65 FR 39206  
June 23, 2000  
(77)

**Final Comments**  
**Revised from the August 21, 2000 Submittal at Public Hearing**  
**on the Draft EIS for the Construction and Operation of an Independent Spent Fuel Storage**  
**Installation on the Reservation of the Skull Valley Band of Goshute Indians and the Related**  
**Transportation Facility in Tooele County, Utah, June 2000**  
by Robin Jenkins, Scientist  
September 12, 2000

# Hydrography and Shallow Groundwater Characteristics of Skull Valley

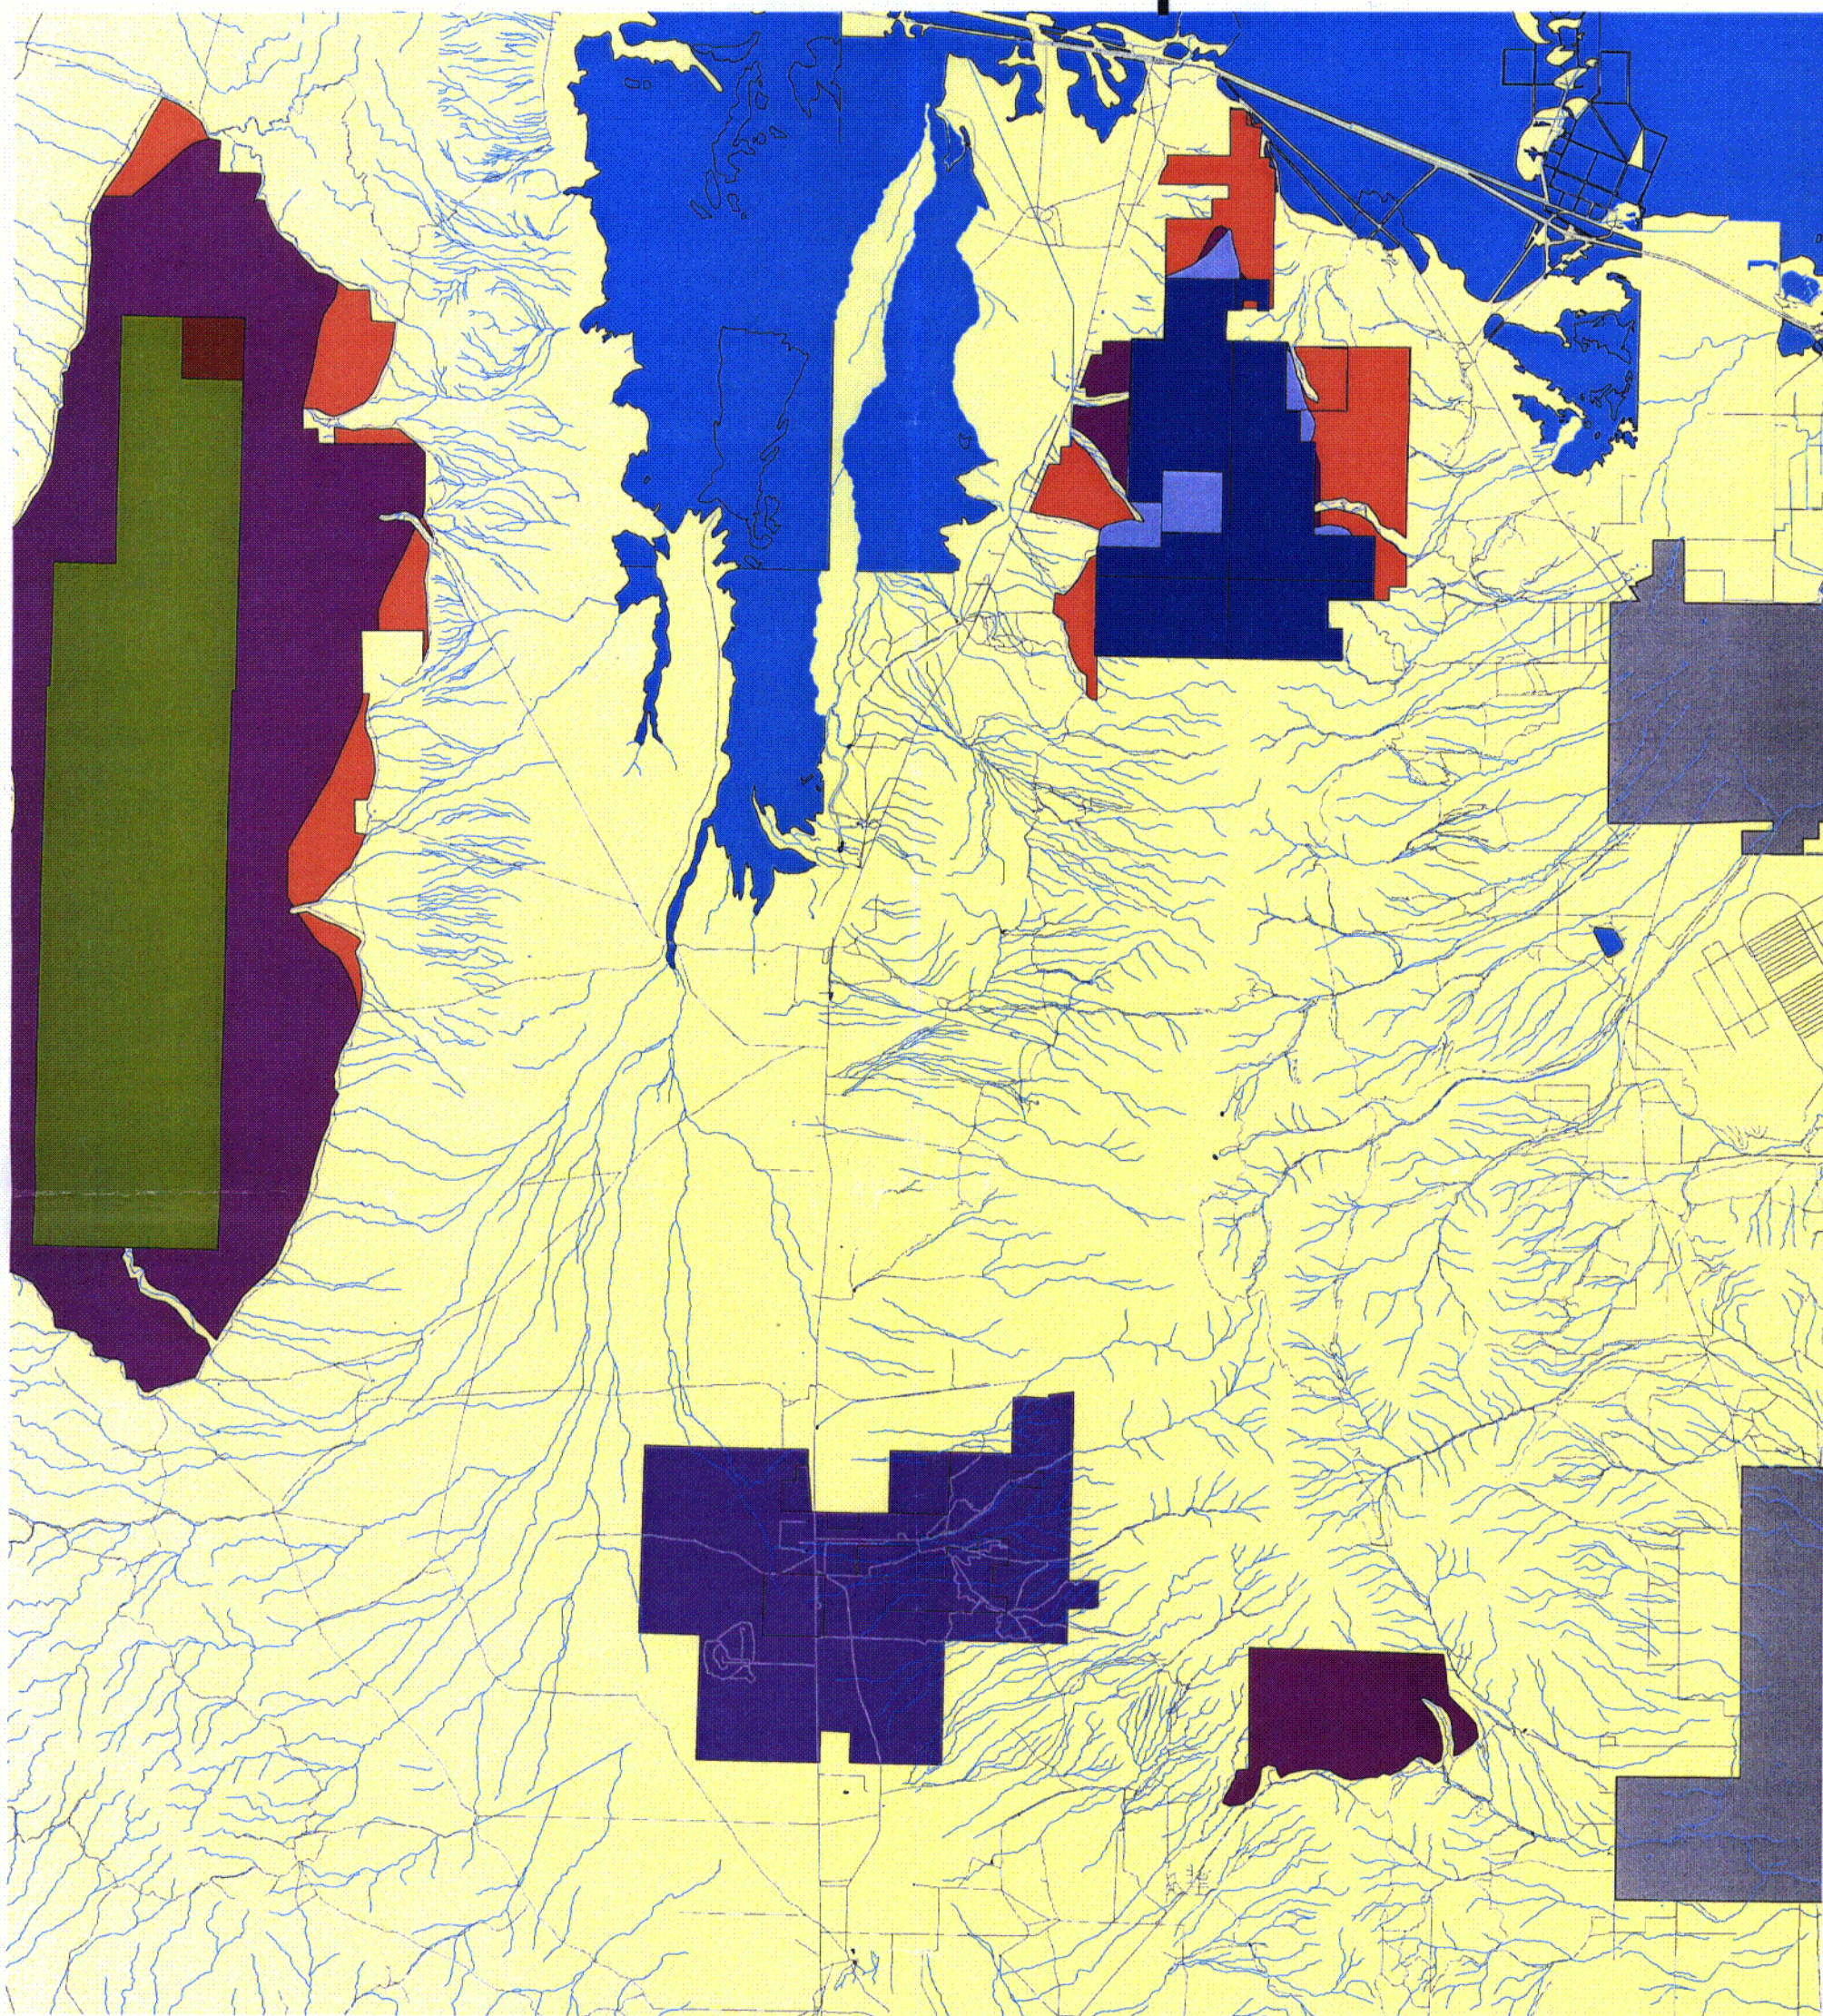
It is stated that a series of borings of un-stated depth were emplaced. Soils were described down to 9 feet deep, and that water content ranged from 9% to 50%. Because moisture generally increases with depth toward a water table, and because shallow groundwater occurs between 3 and 15 feet in most all of Utah's intermontane valleys, the report implies that there may be 50% moisture at 9 feet deep. If so, the capillary fringe or fully saturated conditions (i.e., shallow groundwater) exist at 9 feet deep. Only after laborious review of hundreds of other pages, including the SAR, is any detail at all revealed. The SAR shows geotechnical lab data and soil boring logs indicating moisture contents over 40% at shallow depths and perched water at about 9 feet. Based on the DEIS's own information, there is a shallow aquifer at about 9 feet. This shallow aquifer must be described and discussed. The shallow aquifer in the area of the proposed site is also confirmed by public information published by the state of Utah.
